Planning and Zoning Board

CASE NUMBER: **Z17-002** (PLN2016-00885)
LOCATION/ADDRESS: The 6400 through 6600 blocks of South Mountain Road (west side) and the 6400 through 6600 blocks of the South Signal Butte Road alignment (east side).
GENERAL VICINITY: Located west of Mountain Road and north of Pecos Road.
REQUEST: Rezone from AG to HI-PAD AF (20± acres); and rezone from GI-CUP AF to HI-PAD AF (24.3± acres); and rezone from HI-AF to HI-PAD AF (5.82± acres); and Site Plan Review.
PURPOSE: This request will allow for the expansion of an industrial facility.
COUNCIL DISTRICT: District 6
OWNER: Signal Butte 20 LLC, owner.
APPLICANT: Reese Anderson, Pew and Lake PLC
STAFF PLANNER: Wahid Alam, AICP-Planner II

STAFF RECOMMENDATION: Approval with Conditions

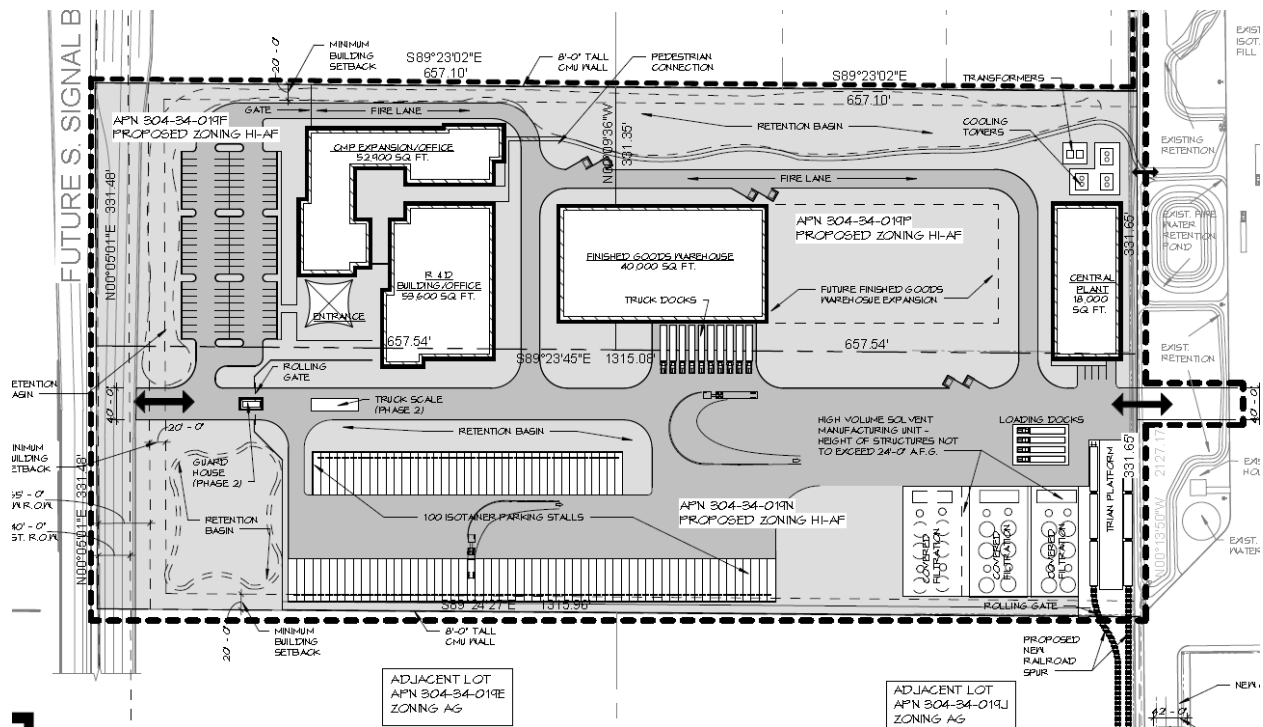
The proposed Isotainer expansion area north of the existing facility and the Phase 1 site plan for a portion of the 20-acre expansion is shown in the figure above. Until Signal Butte Road is constructed, the proposed development will the existing Pecos Road and Mountain Road access for its daily operation. The items included in this site plan are:

- 1) Central Plant Building for 18,000 square feet, including cooling towers and transformers;
- 2) High Volume Solvent Manufacturing Unit; and
- 3) Isotainer storage/parking area both on the expansion area and in the area along the north property line of the existing operation.

Staff has no concerns with the site plan as proposed. There are, however, a couple of site issues that do need to be resolved with this development.

Two issues relate to development of the street network. Normally, the City codes require the immediate dedication and improvement of the adjacent section line road, Signal Butte in this case. However, none of this street exists in this area. Plus, with the planned expansion of State Route 24, at least some of the Signal Butte right-of-way will be part of the ADOT right-of-way. Because of these issues the City would prefer to delay the dedication of this right-of-way and construction of the roadway until an appropriate time in the future when the final right-of-way needs are determined and there is a need to build more of the roadway. The details and timing of this are to be worked out in a Development Agreement to be approved by Council prior to the approval of the rezoning.

An associated street network need has to do with the three lots to the north of the proposed Fuji west expansion area (shown as lots on the site plan with APNs 304-34-019Q, 019R, and 019S). These lots are currently land locked. Their only option for access is for a street to be constructed centered on the property line on the north side of the Fuji expansion area (APN 304-34-019F). The street may need to jog south before connecting to Signal Butte due to the approach to State Route 24. The City's street system normally requires a street in this location and the Zoning Ordinance does not allow for creation or development of landlocked parcels. When a final site plan is developed for the northern portion of the Fuji property it will need to include land for this right-of-way extending east to include a cul-de-sac centered on the point where parcels 304-34-019F, 019R, and 019S meet. The details and timing of this are to be worked out in a Development Agreement to be approved by Council prior to the approval of the rezoning (see condition #9).

The final issue is the provision of water and sewer service to the west expansion area. The applicant has provided a letter describing how these services can be provided. The information provided is preliminary but demonstrates their understanding of the situation and commitment to providing the needed service even if it means extending new service lines in their private drive from Pecos (see condition #10).

8. Replacing the proposed chain link fencing with a permanent wall consistent in design with the wall proposed for the south property line either with the development of Phase 2 of the expansion area or the construction of Signal Butte Road, whichever occurs first.

9. Execution of a Development Agreement including but not limited to provisions for the dedication of all right-of-way and construction of roads.
10. Each phase of development must comply with the City's water and sewer requirements.
